DRY RIDGE TRAIL COMPLEX
Ranchester 12-18-75

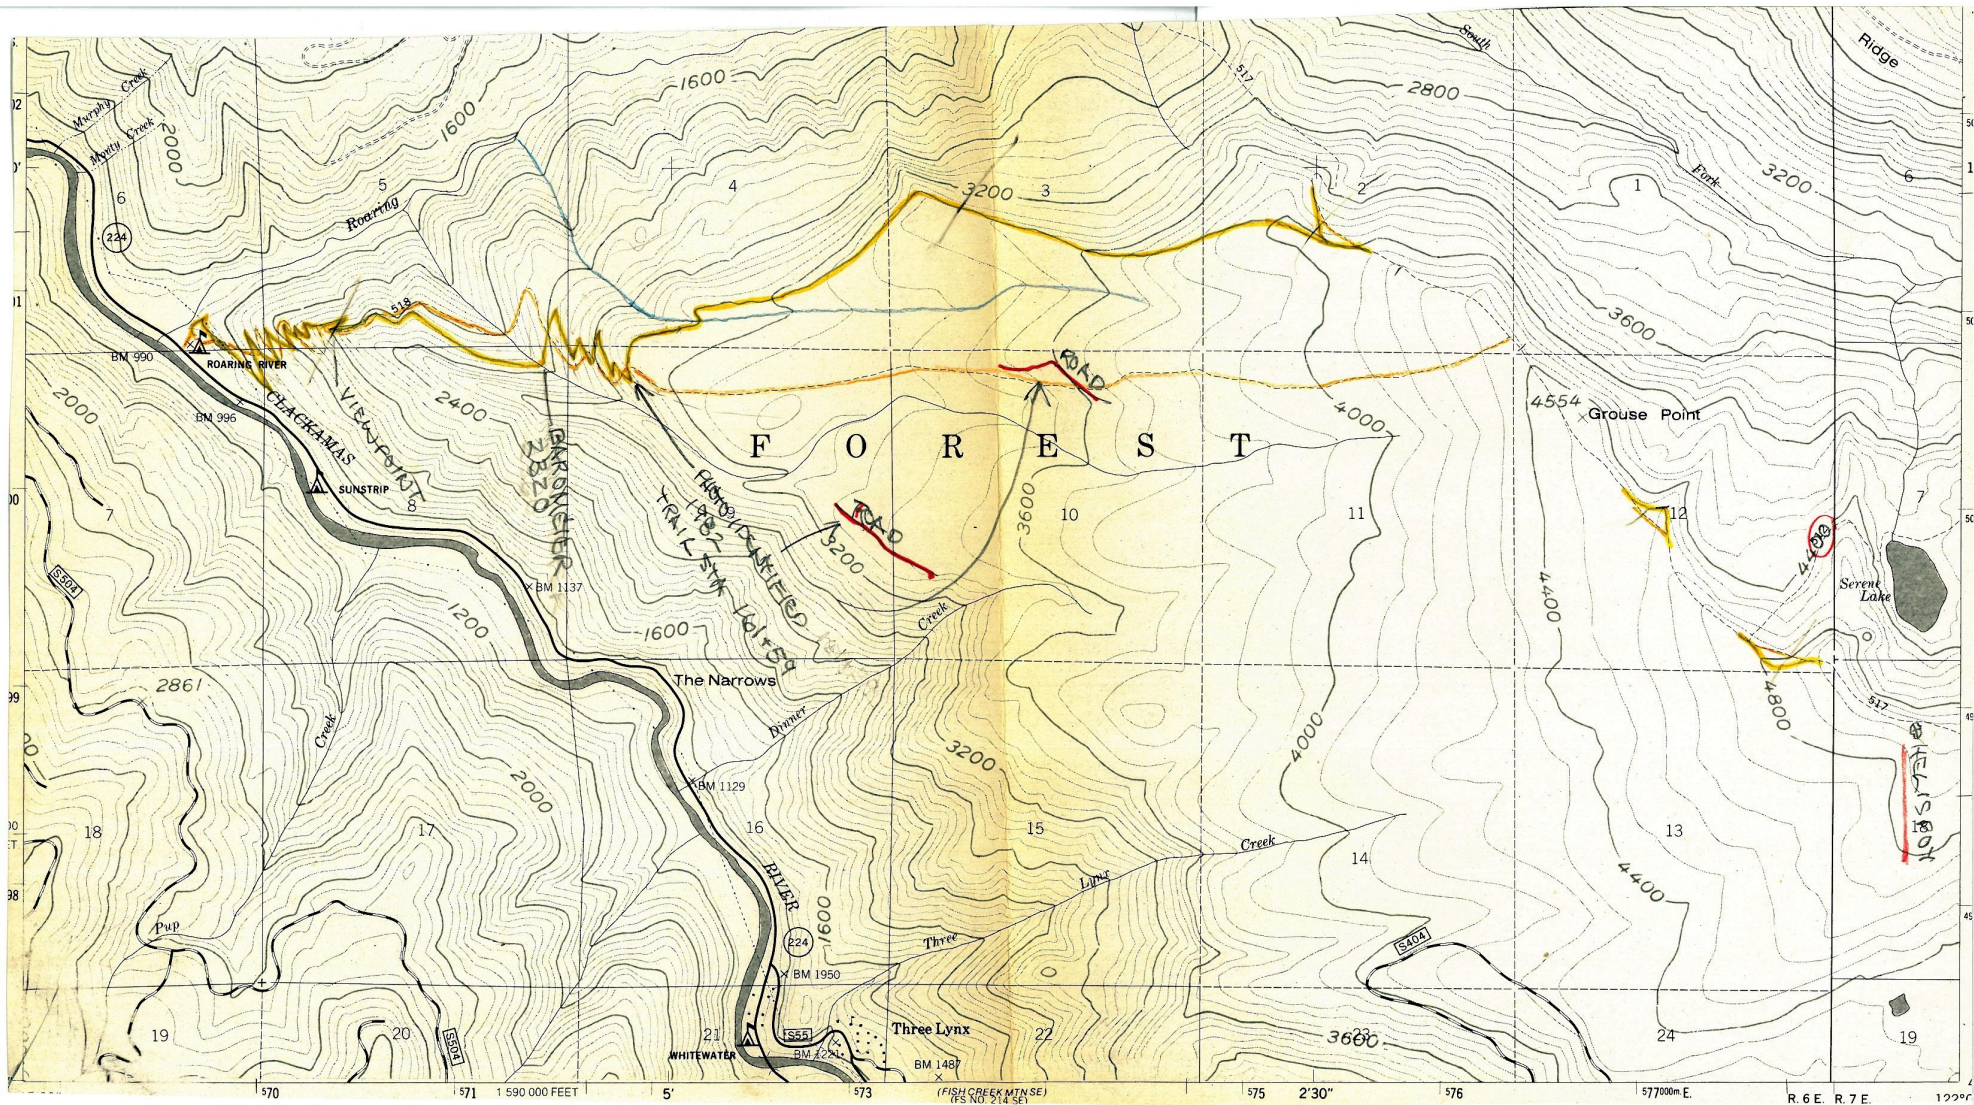
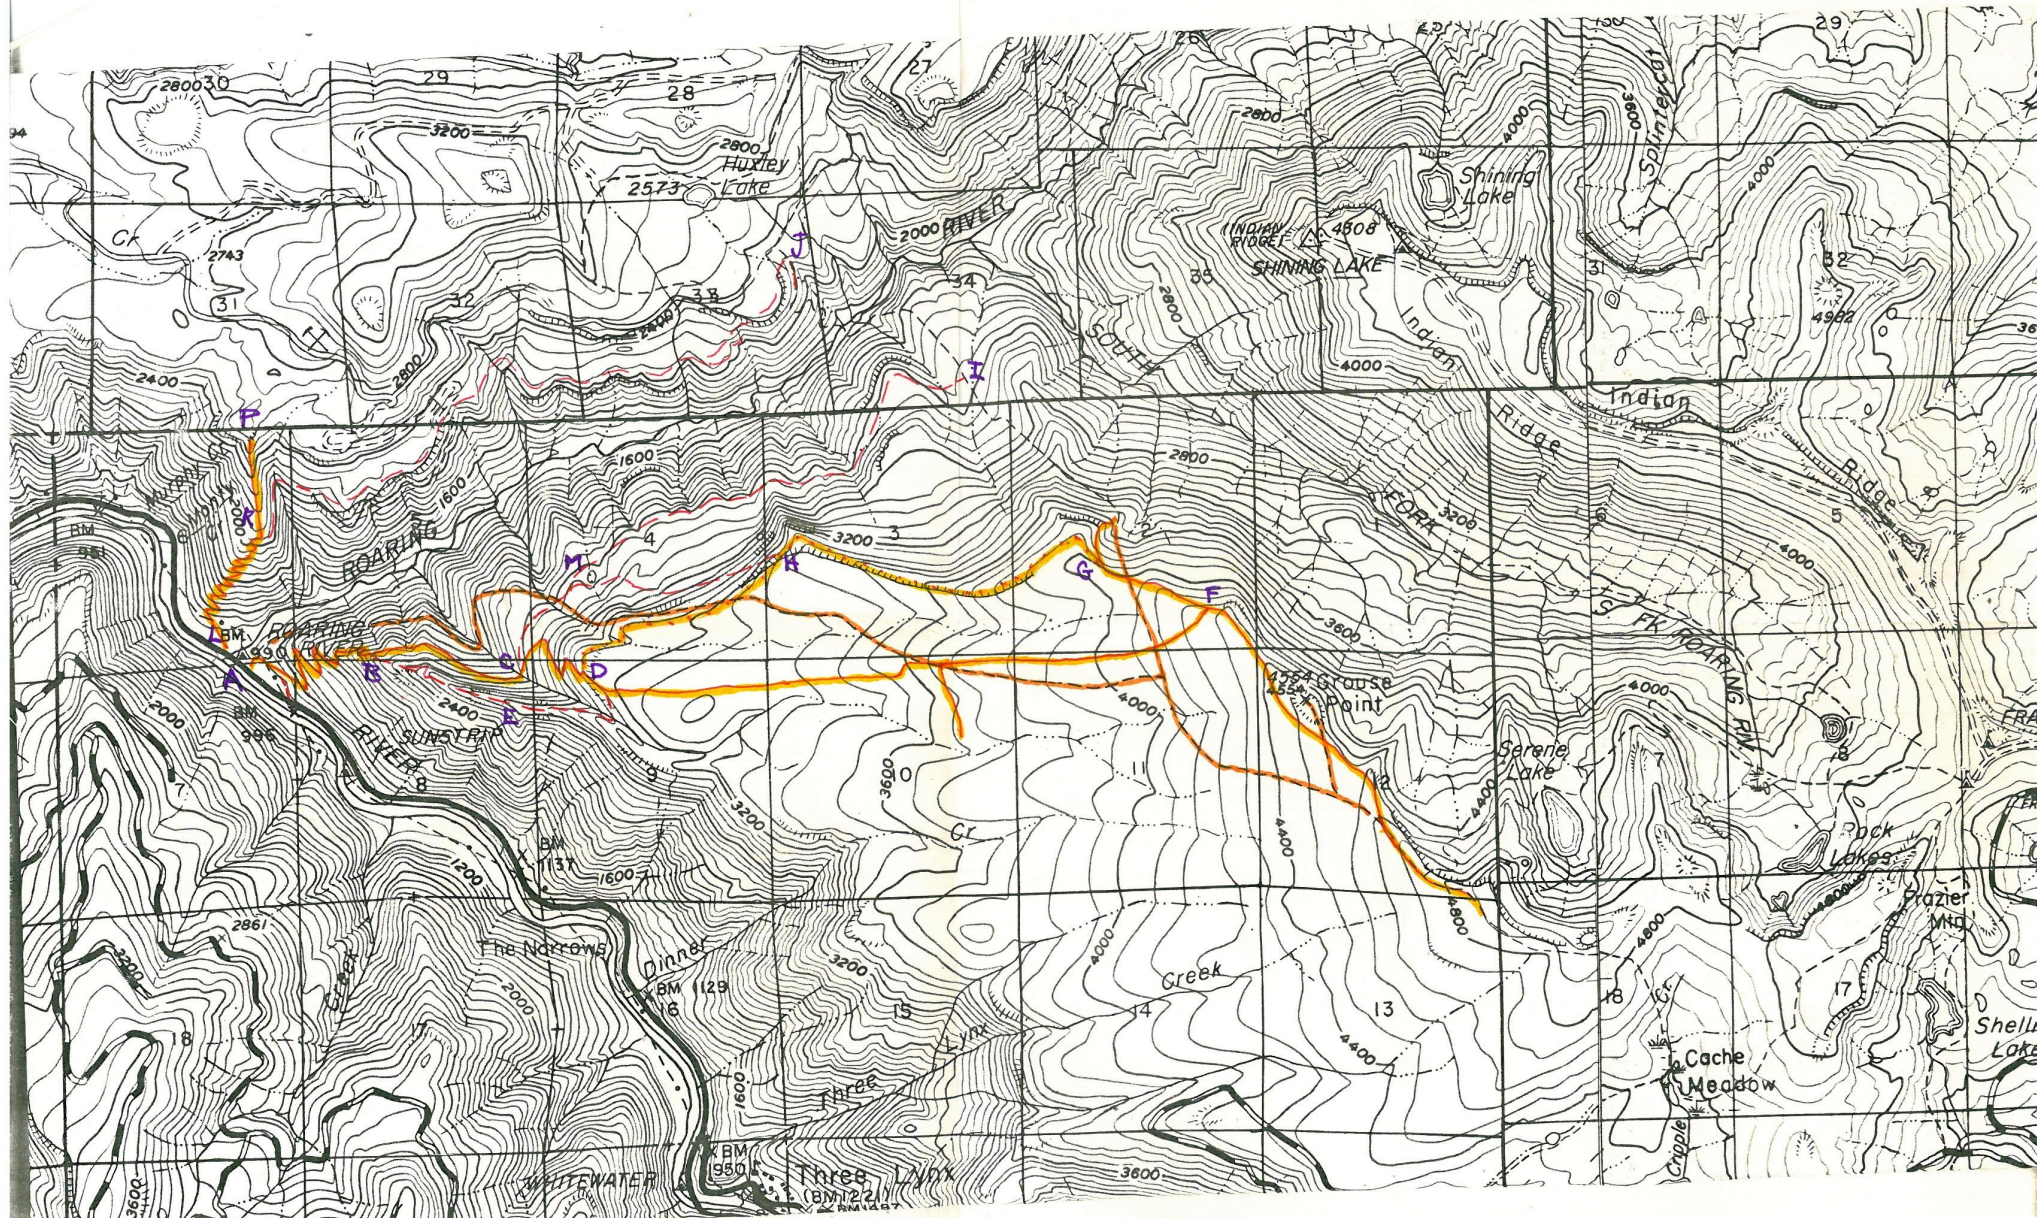
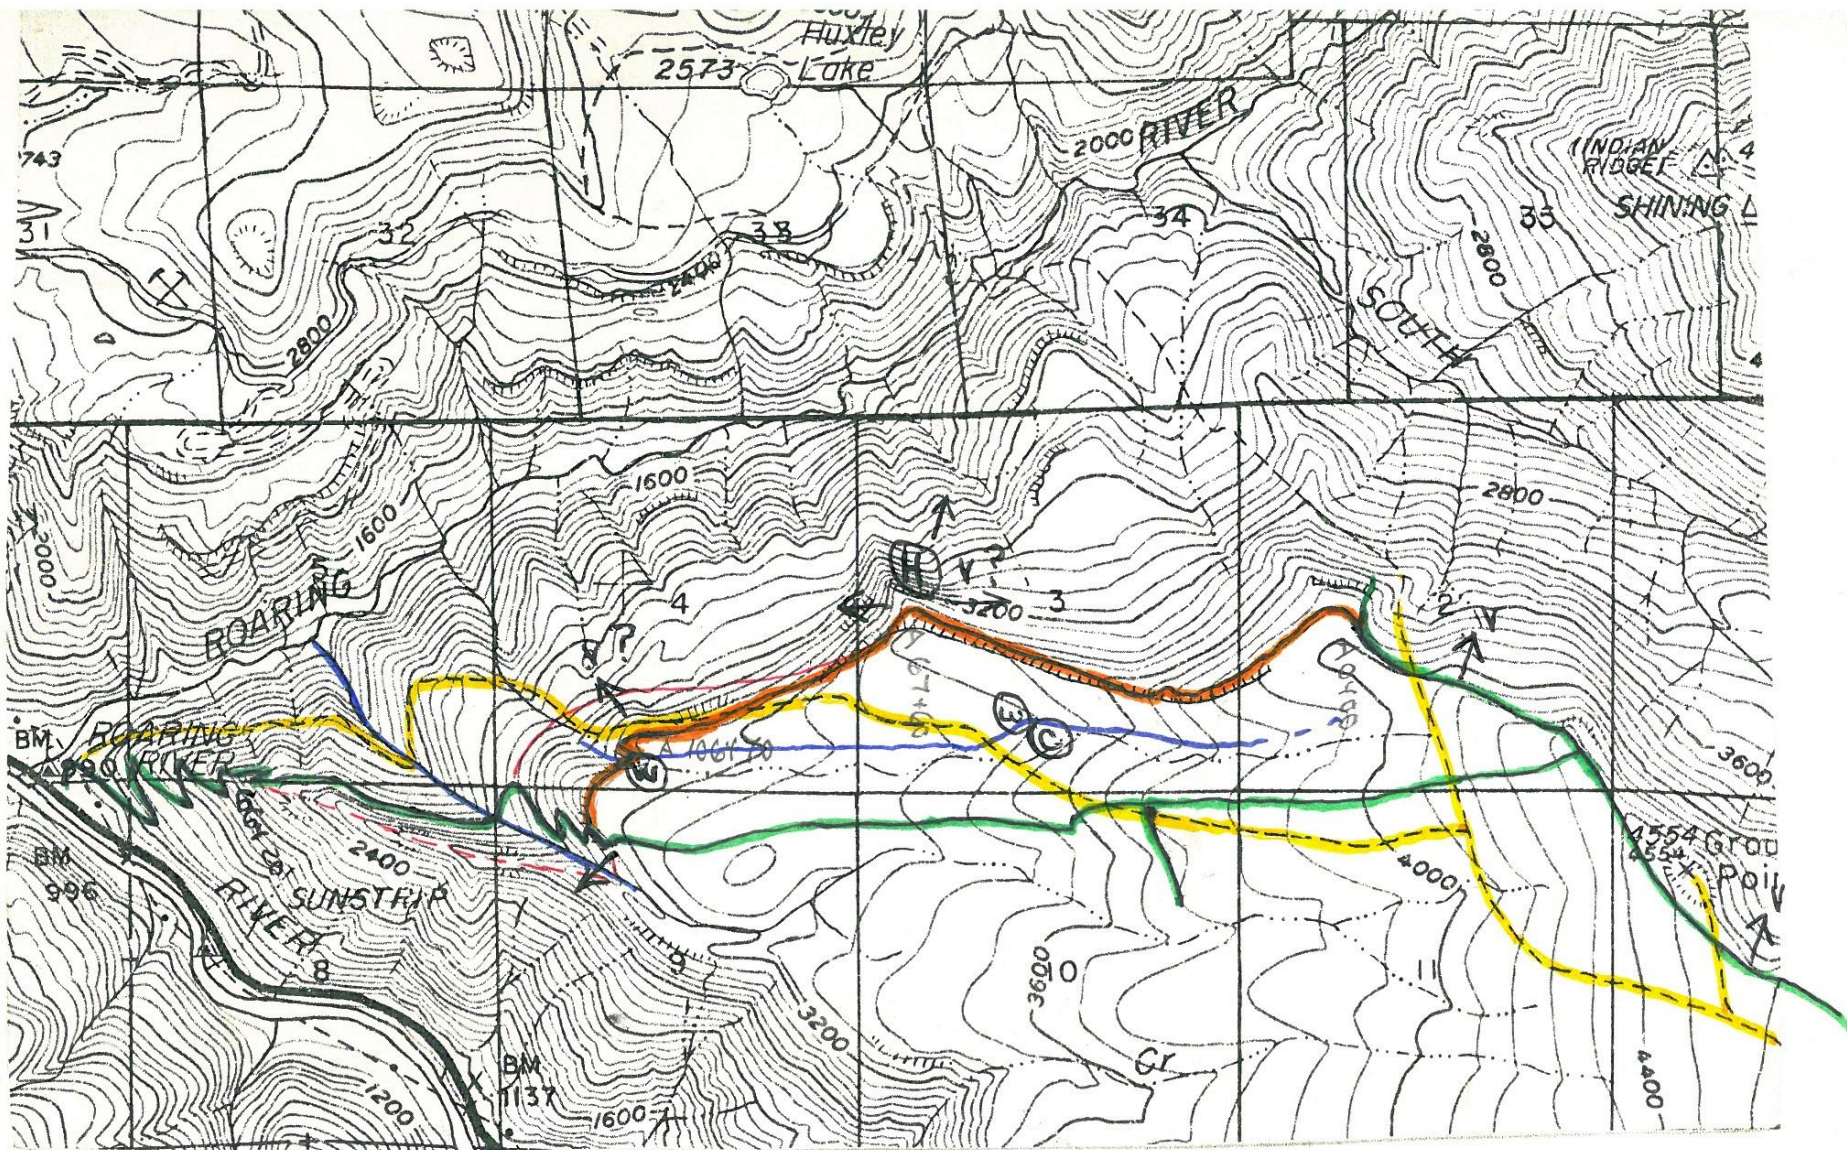
A-B-C IS ADEQUATE ROUTE AND SHOULD BE
RETAINED AS IS.

C-I SHOULD BE EXPLORED. IT OFFERS
A LOW ELEVATION ROUTE TO CONNECT
WITH I-J-K-L

D-F SHOULD BE ABANDONED

F-G IS ADEQUATE.

G-H SHOULD BE BUILT AS STAKED, WITH
HELISPOT TO BE BUILT ON THE
RIDGEPOINT NEAR "H"

H-D IS FEASIBLE, AND TIED TO D-C,
WOULD REPLACE D-F.

H-M-C IS AN ALTERNATE PROPOSAL, BUT
HAS NOT BEEN EXPLORED. IT HAS
SOME ADVANTAGES TO H-D-C.
IT WOULD KEEP TRAIL ON COOLER
ASPECT. IT WOULD ^{REPLACE} A RELATIVELY
STEEP ROUTE C-D. IT WOULD
CROSS A GOOD STREAM NEAR "M"
WHERE CAMPSITE COULD BE
DEVELOPED. IT WOULD TAKE CARE
OF A SEGMENT IN CONSTRUCTION
OF C-M-I

C-D SHOULD BE KEPT AS A PRIMITIVE
HIKER ROUTE TO THE GOOD VIEW POINT
AT "D".

D-E-B SHOULD BE EXPLORED AS A POSSIBLE

G-I-J

NEEDS MAP LOCATION VERIFIED
AND NEEDS A CONDITION SURVEY.
IF RELOCATION IS NECESSARY, IT
SHOULD BE LOCATED WITH GRADES
UP TO 20%, BUT AVERAGING 15%

J-K

NEEDS TO BE EXPLORED. IT
WILL PASS THRU SEVERAL OLD
CLEAR-CUTS BUT SHOULD OFFER
GOOD VIEWS. IT WOULD COMPLETE
A LOW-ELEVATION ROUTE.

K-P

UGHT TO BE ABANDONED.

K-L

IS AN OLD UN-MAINTAINED
TRAIL. IT IS VERY STEEP BUT
FAIRLY WELL-BUILT. IT IS SO
ILL-DEFINED THAT A DIFFERENT
ROUTE WITH LESSER GRADES MIGHT
BE DESIRABLE
